The Foxboro Company

Public Service Company of Colorado
Fort St. Vrain Nuclear Generating Station
Mr. R.O. Williams, Jr. V.P., Nuclear Operations
P.O. Box 840
Denver, CO 80201-0840

Subject: Potential Deficiency Affecting Foxboro N-E11 and N-E13
Transmitters Containing 10-50mA Type Amplifier
Pt. No. B0142EC
Manufactured between January 1, 1988 and September 1, 1989

Figure No.1

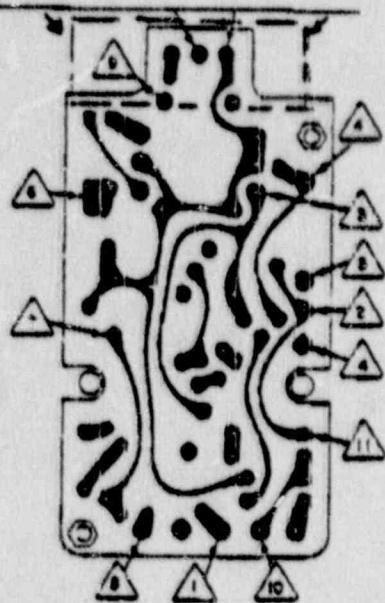
The deficiencies are workmanship related consisting of: 1) component leads were incorrectly soldered, and/or 2) improper component lead position and trimming which could lead to grounding or bridging of circuits and possible arcing of a connection, and/or 3) possible omission of a soldered jumper "C".

The workmanship deficiencies have been localized to a particular area of the amplifier board and three specific components and their leads. The components are Q3, an output transistor; CR8, a zener diode; and C3, a capacitor. See the attached Exhibit A, Figures 1 and 2 of this notice which identifies the deficient area and components associated with the deficiencies.

Area of Incorrect Soldering

All amplifiers date coded 2B8801 through 2B8936, whether shipped as a component of a transmitter or as a spare part, must be replaced because of the discussed deficiencies. To aid in locating all of these amplifiers at your facility we advise you that transmitters shipped between January 1, 1988 and September 1, 1989 may contain the affected amplifier. In addition, please be certain to check your spare amplifiers for these date codes. The amplifier date code is on the back of the mounting side of the amplifier on a label which states plant of manufacture, and the year and the week of manufacture.

Amplifiers must be replaced and will not be repaired by Foxboro. The 1988 to 1989 time frame has been identified through return failure analysis and stock inspections as the only period wherein the subject amplifier Part Number B0142EC has the identified deficiencies. Analysis and testing determined that the deficiency was not caused by the components but by workmanship deficiencies.

Figure No.2

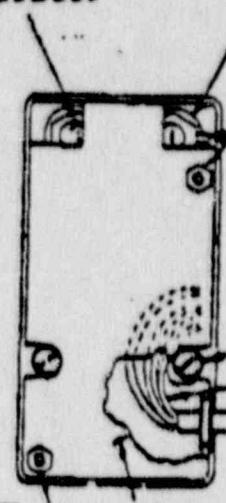
Transmitter operation can be affected in the form of current output oscillations which may suddenly occur because of bridging and/or contact resistance changes from improper connections. In the case of a loose cathode tab connection with the zener case, arcing will occur which will cause current output oscillations. Incorrectly soldered connections and/or a loose zener tab could individually, and in some combinations, cause output oscillations. Some amplifiers shipped as spare parts were missing the "C" jumper. These amplifiers would experience output oscillations immediately upon test powering, thus indicating that the amplifier was unusable.

Cathode Tab

Figure No.3

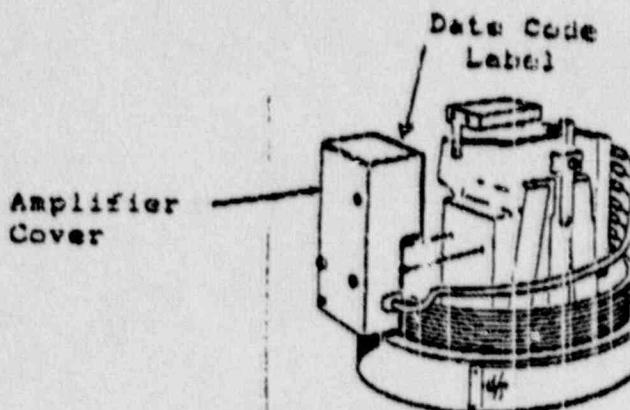
See attached Exhibit A, Figure 3 for location of the date code.

The number below the date code is an amplifier serial number.
